**Subject: Request for advice on Environmental Impact Statement – TOD - 30-34 Sir Joseph Banks Street, Bankstown (SSD-86274959)**

**CPHR comments on EIS – TOD – 30-34 Sir Joseph Banks Street, Bankstown (SSD-86274959)**

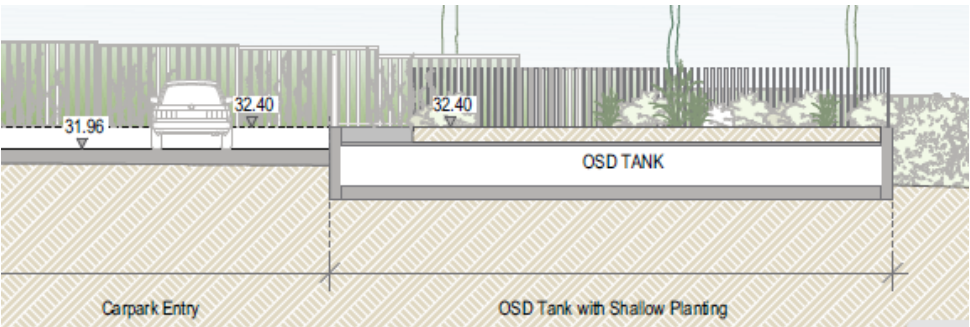
<p>1.</p>	<p>Adequacy of the AIA</p>	<p>The AIA states that the on-site stormwater detention (OSD) and driveway will be constructed at or above existing ground levels. However, the Landscape Section 2/2 Plan (dwg DA-LA06, revision B) (excerpt below) indicates that both the OSD tank and driveway will require varying degrees of excavation into the existing ground and therefore has potential impacts to Tree 38 and Tree 40.</p>  <p><b>Recommended actions:</b></p> <ul style="list-style-type: none"> <li>• Provide a Longitudinal Plan clearly showing the relationship between the driveway, OSD and existing ground levels.</li> <li>• Further assess potential impacts to Tree 38 and Tree 40.</li> <li>• Provide an updated AIA demonstrating how Trees 38 and 40 will be viably retained, including the provision of more detailed specifications on how this will be achieved.</li> <li>• Include a new section in the AIA titled 'Tree Protection Specifications', clearly outlining tree and site-specific protection measures in accordance with Sections 1.3.21 and 2.2.6 of Australian Standard 4970–2025. Generic measures are not acceptable.</li> <li>• Relevant plans are to be updated in consultation with the consulting arborist as required to ensure the viable retention of the subject trees.</li> </ul>
